Littleton King Street Common Phase 1 Retail Development - Peer Review

December 15, 2025

Review by Utile Architecture and Planning

Building-Specific Scale Comments: Building 1500

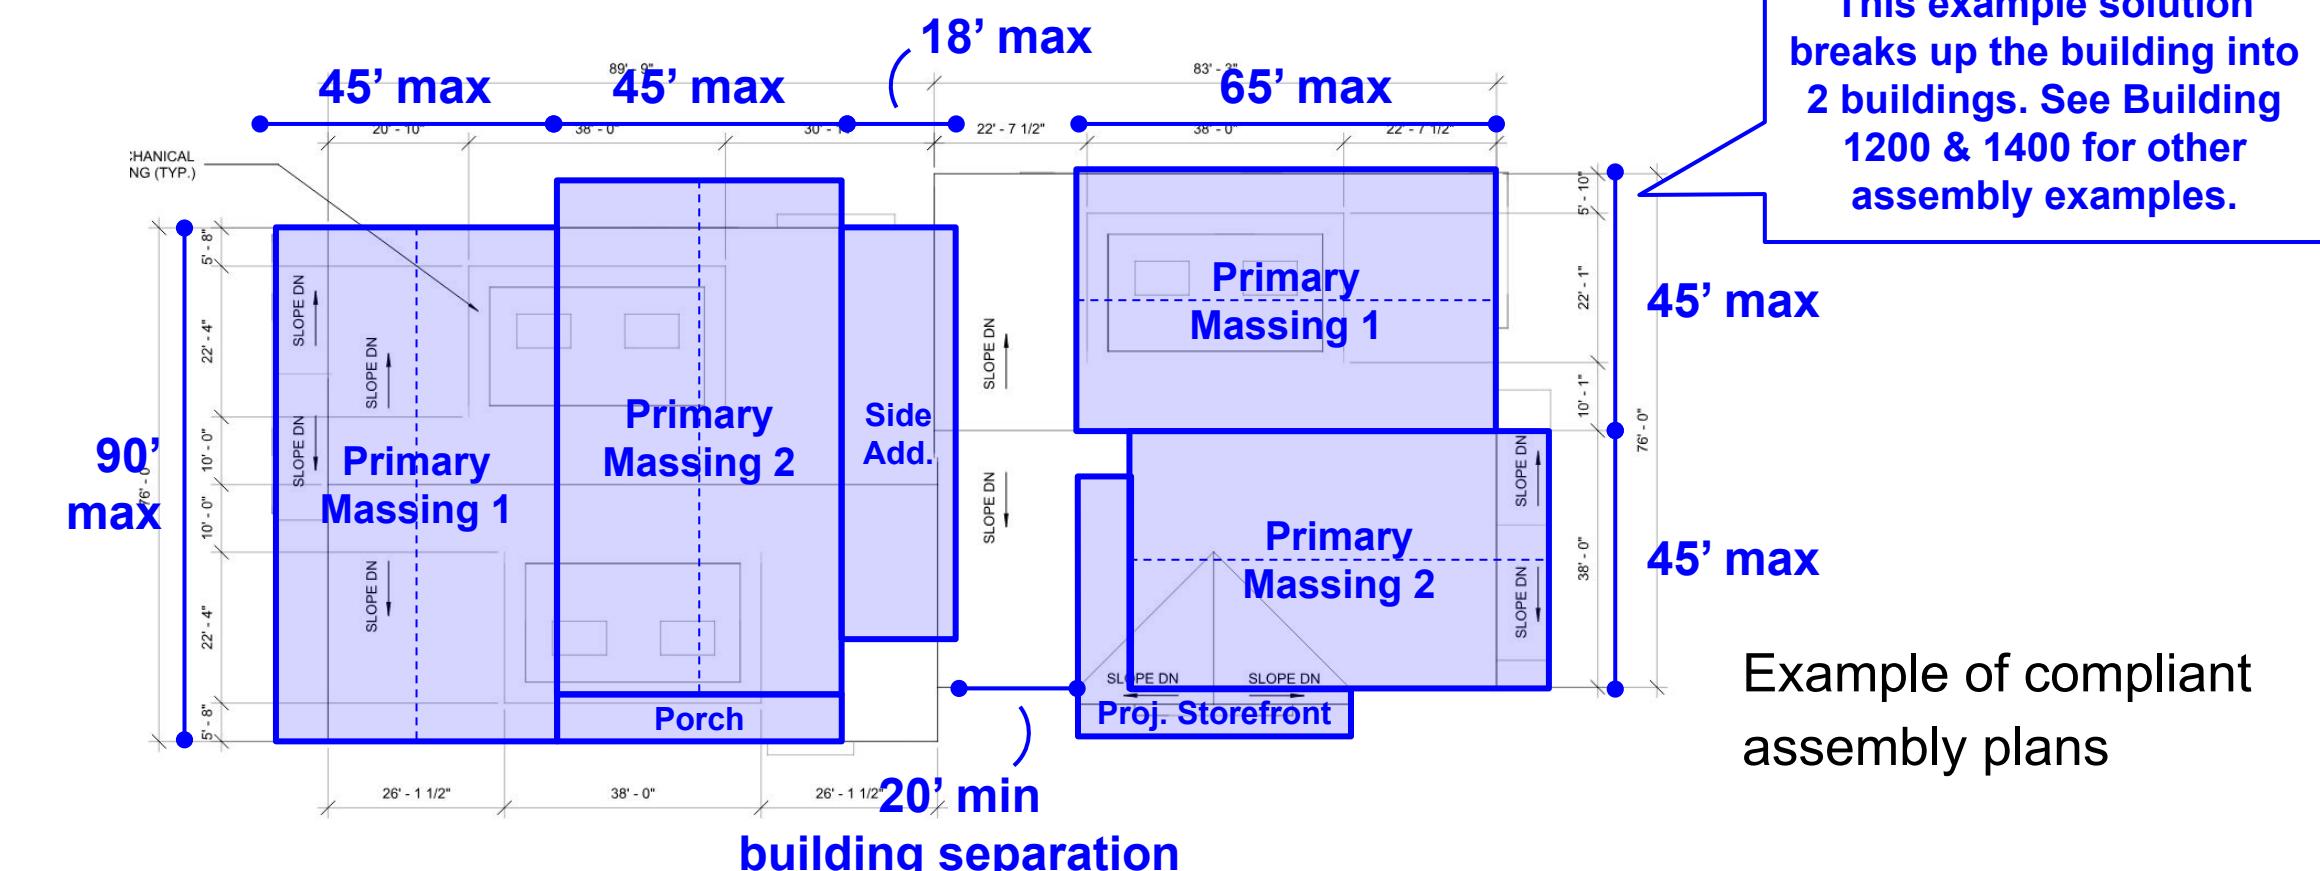
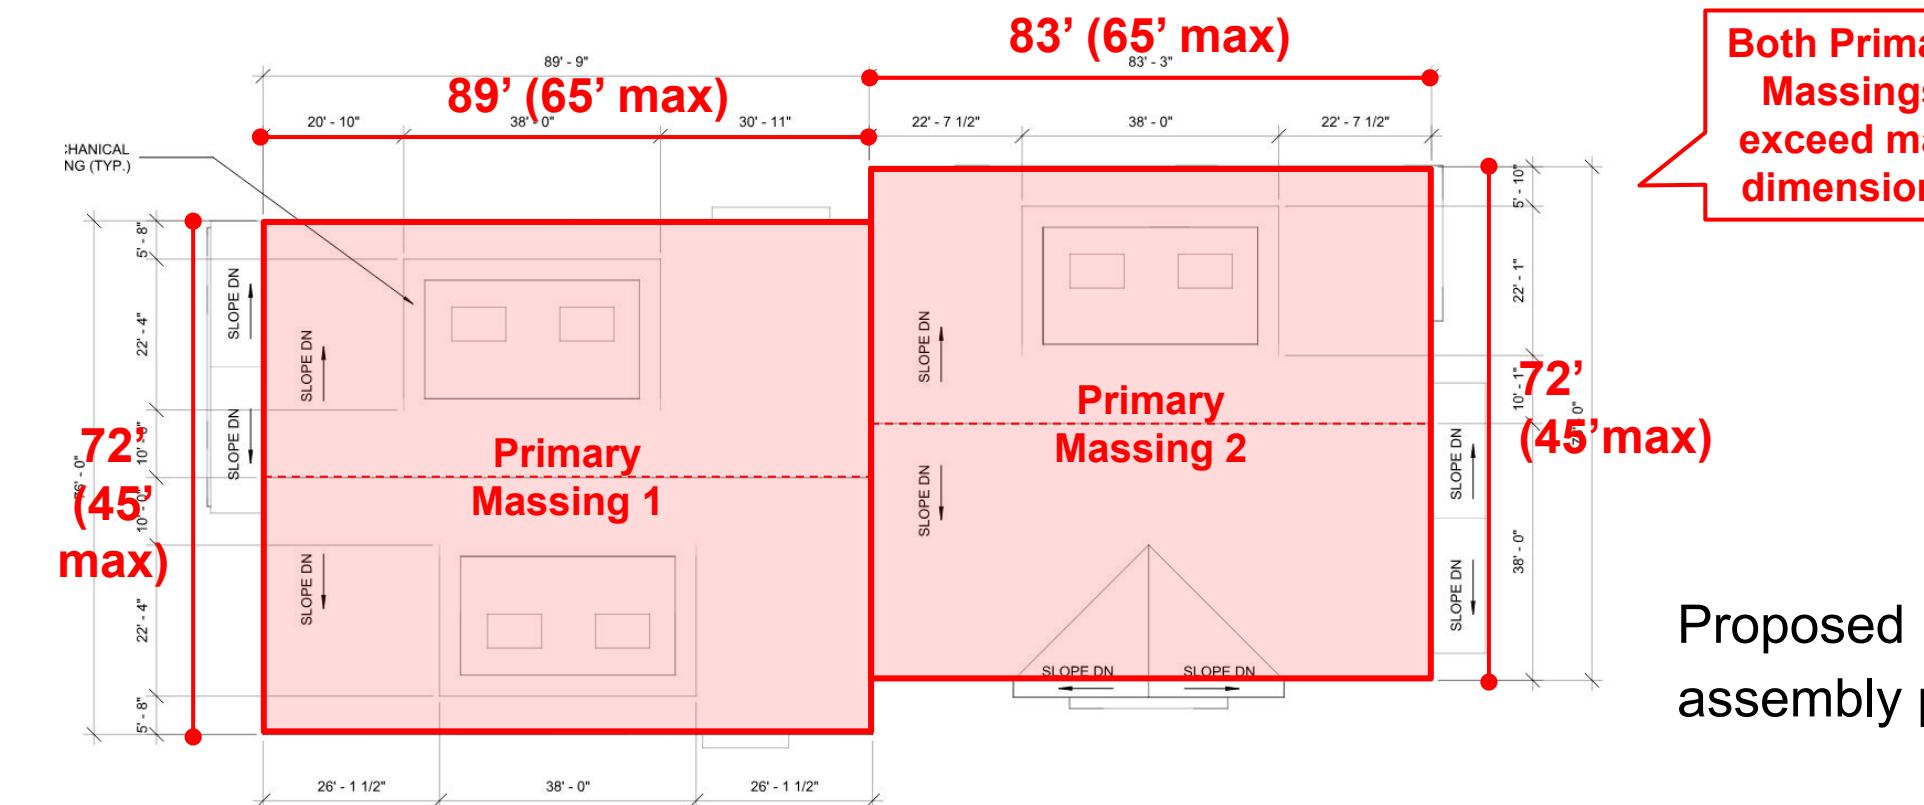
Similar to Building 1200 & 1400, Building 1500's two primary massings both exceed the maximum allowable dimensions. The east primary massing is 89' wide by 72' deep, equalling an area *more than double* the allowable maximum for a single primary massing (65' wide by 45' deep, when the long side is oriented parallel to the ROW), resulting in an oversized building. (§173-221.K.)

As mentioned earlier, reducing the perceived building scale does not necessarily mean a significant reduction in the total building area / footprint – there are multiple options to create an assembly out of primary massing(s) and building component(s) that retain most/all of the area (see one example at right). (§173-221.M. Example

Building-Specific Scale Comments: Building 1500

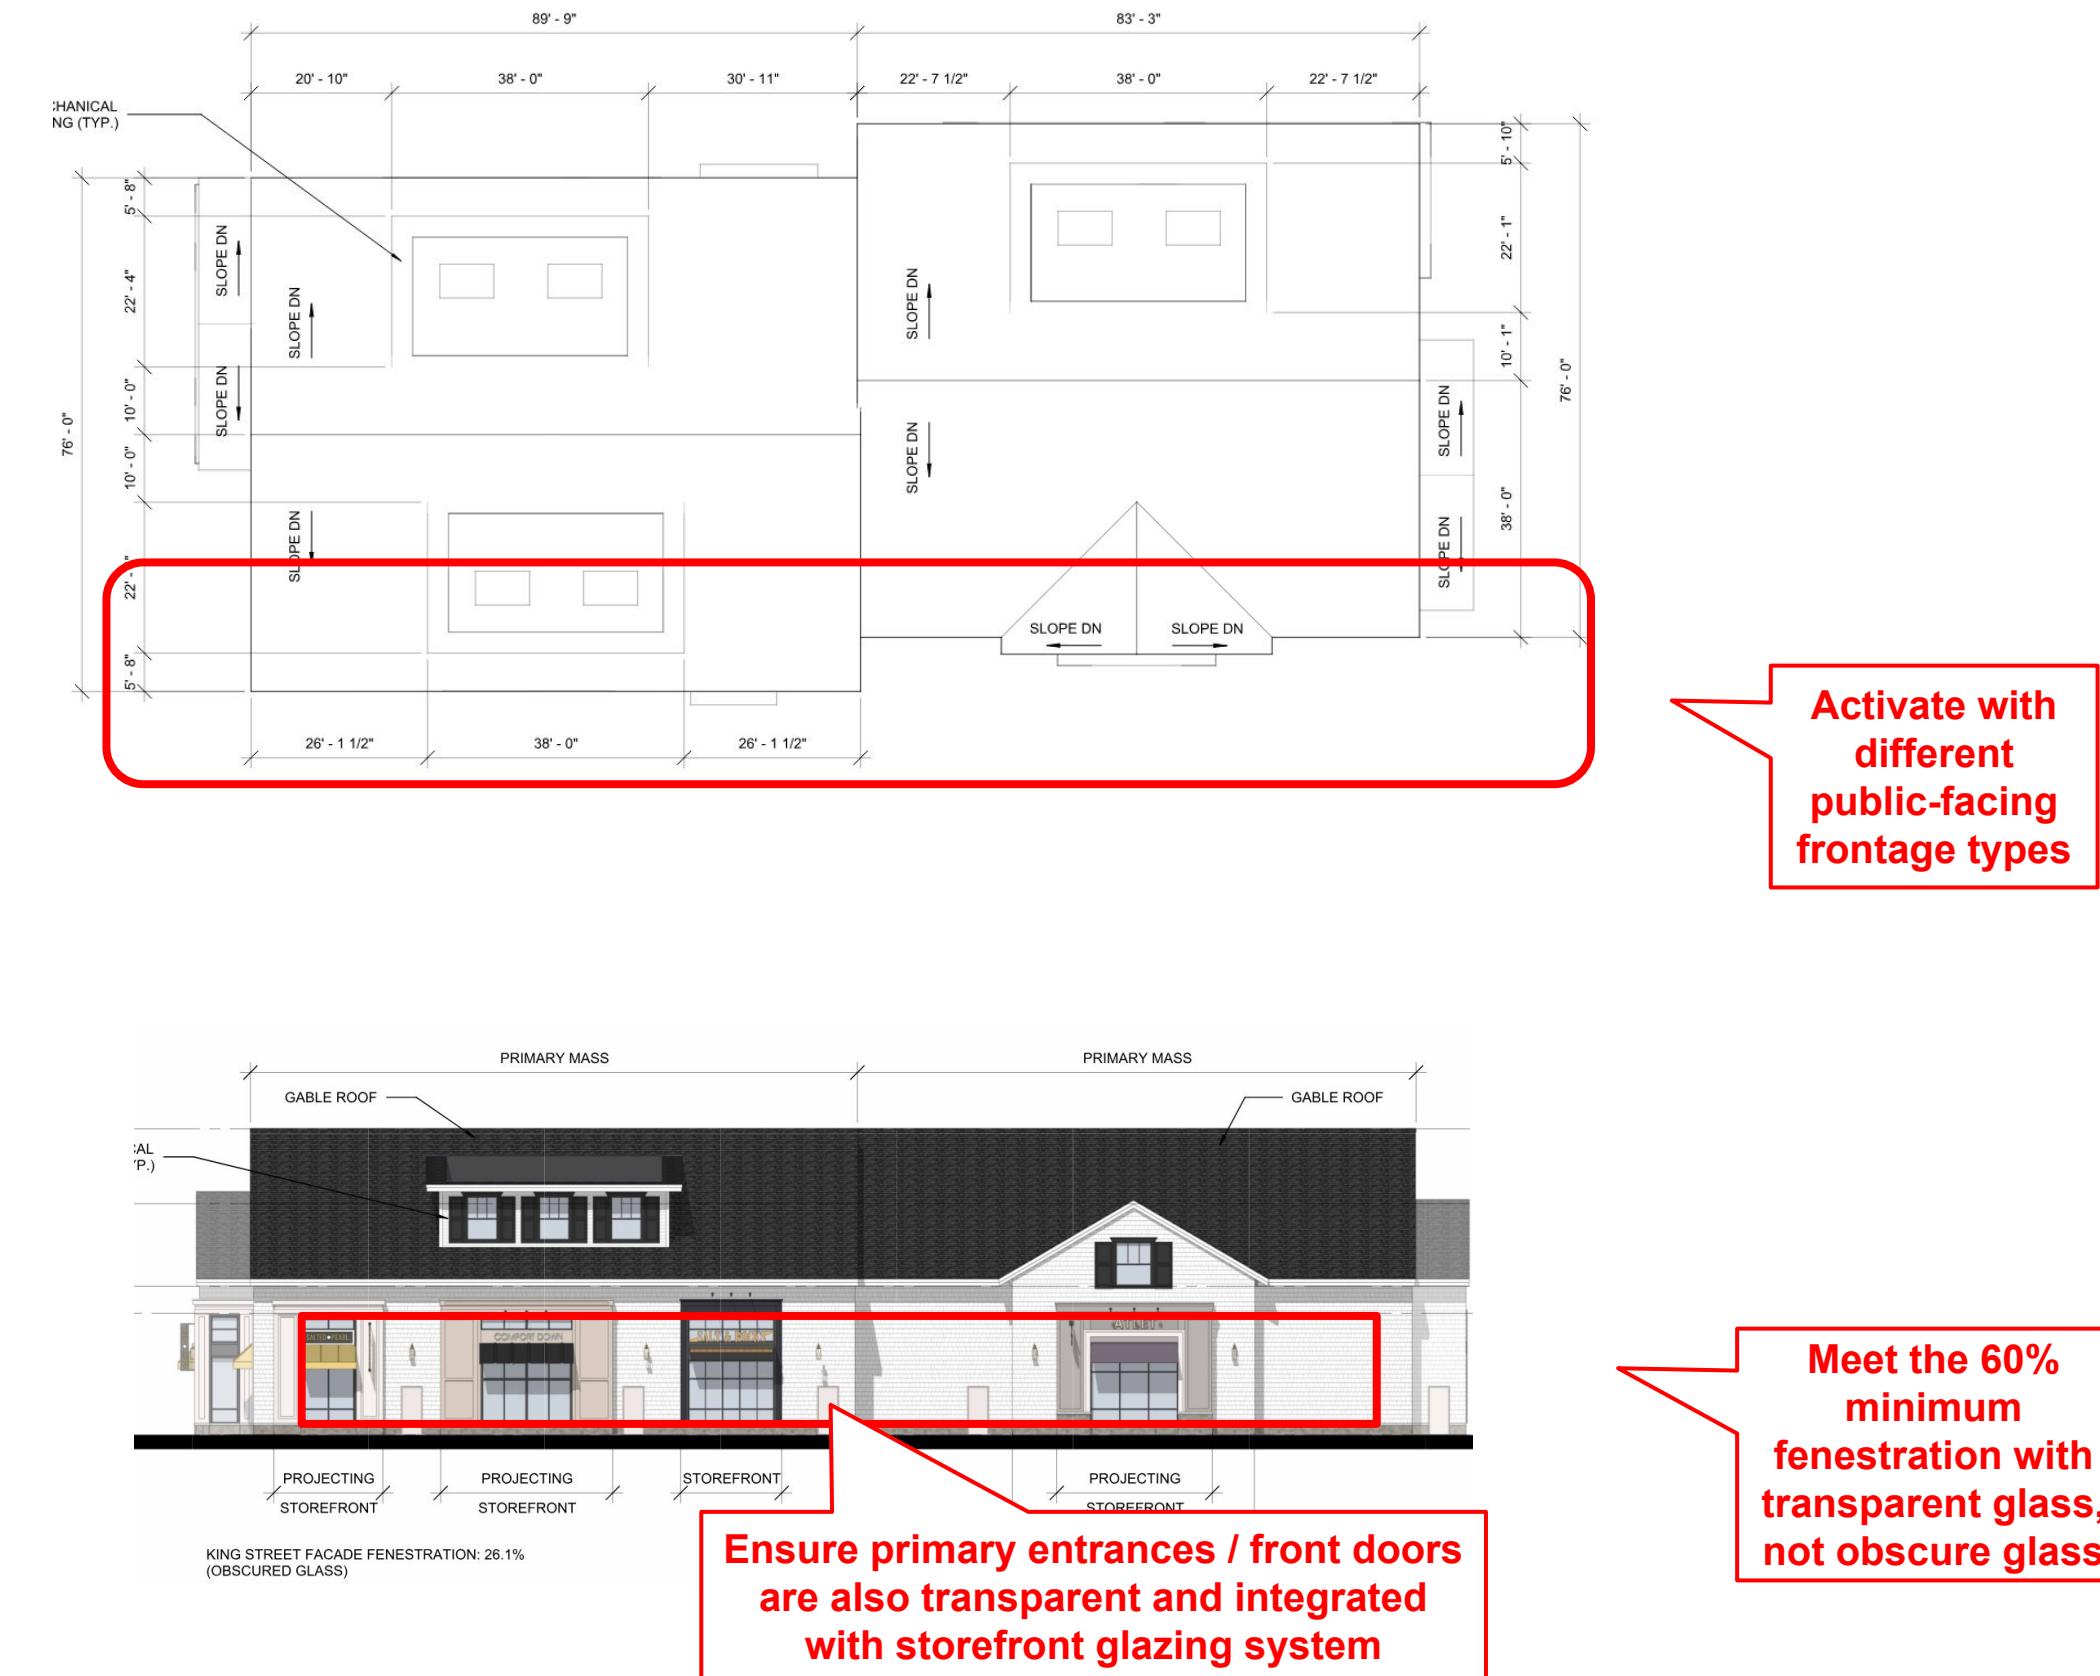
As mentioned earlier, the 3 buildings along King St (1200, 1400, and 1500) have effectively turned their backs onto the public way. To address this:

First, ensure the frontage area is a consistent with one of the *frontage types* that activates the sidewalk (e.g., entry plaza, dining patio, etc.). ([§173-221.N. Frontage Types](#))

Second, ensure that the *fenestration* along King St (aka window transparency percent) is at least 60% and made up of transparent glass, not obscure glass. ([§173-221.G. Fenestration](#))

Lastly, ensure that there are ample *front doors* / *primary entrances* along King St to invite pedestrians and signal a welcoming and active street environment. ([§173-221.J.b. Principal Entrance](#))

Reduce the garage height from 5 to 3 or 4 stories

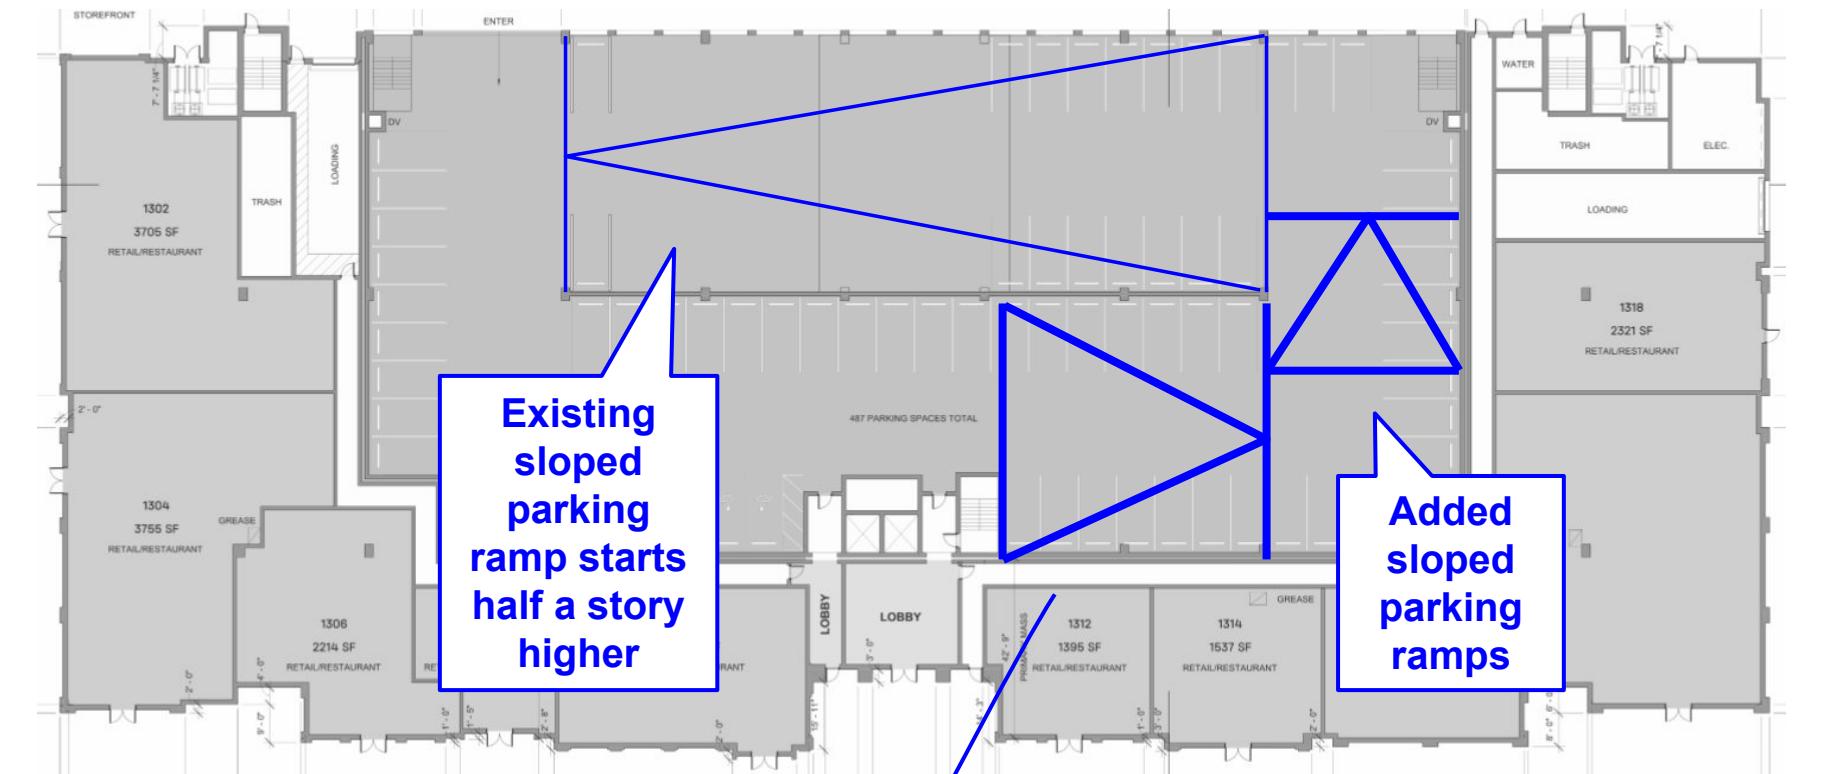
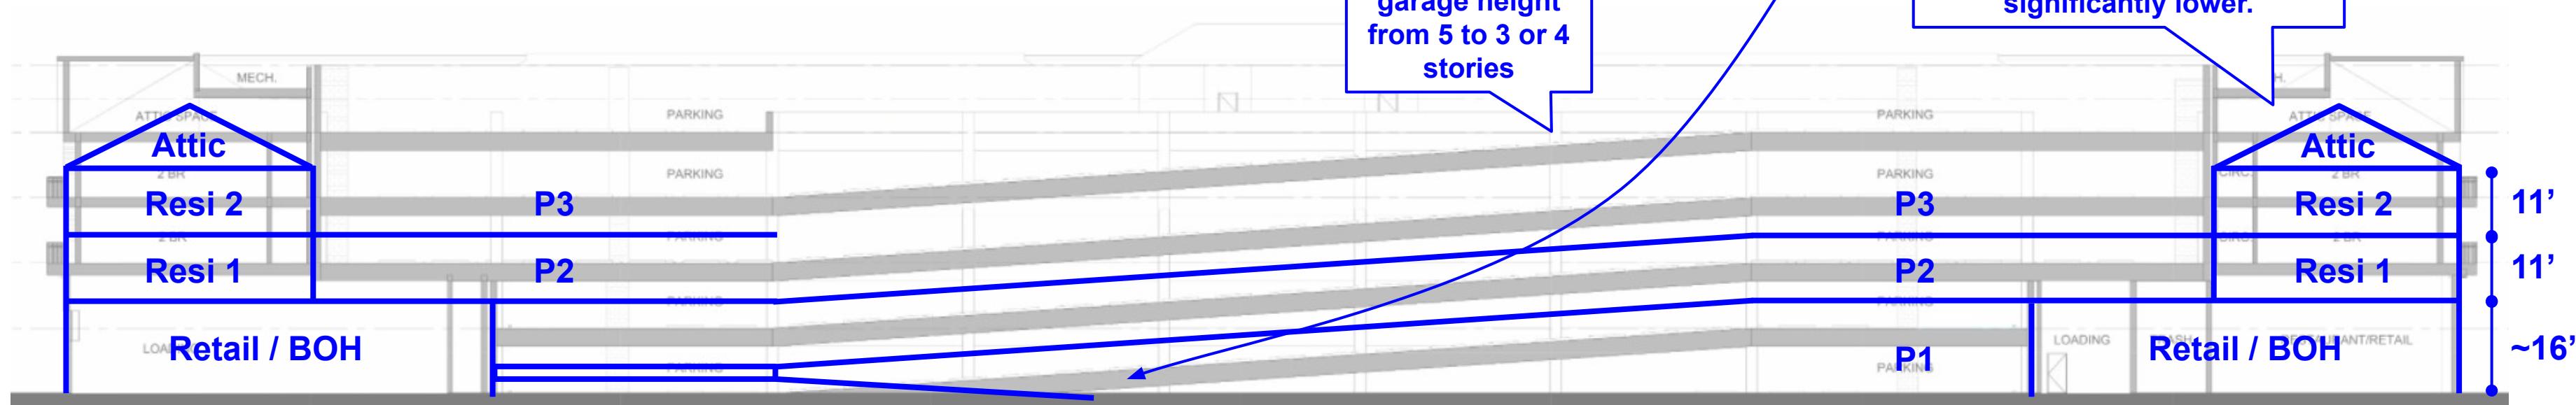
As demonstrated in Comment #1, there is ample room to reduce the garage parking supply. This option reduces both the garage height (by 1-2 stories) and the mixed-use building height (by half a story) without losing any residential and commercial area. This is accomplished by adding and starting the ramp earlier on the ground floor and aligning the 2nd level of the garage with the 2nd level of the residential program (instead of 2 levels of parking for 1 level of retail).

Importantly, a parking garage in this KSC FBC district is limited to 35 ft ([§173-233.H.a. Maximum Height of Buildings](#)), because MIXED USE in ARTICLE II DEFINITIONS is defined as only residential and commercial (does not include parking use). ([§173-2. Terms Defined](#)) Therefore, this building should be governed by [§173-233.H.a.iv](#).

The ground floor retail FTF height is an ample ~16', while the whole building height is significantly lower.
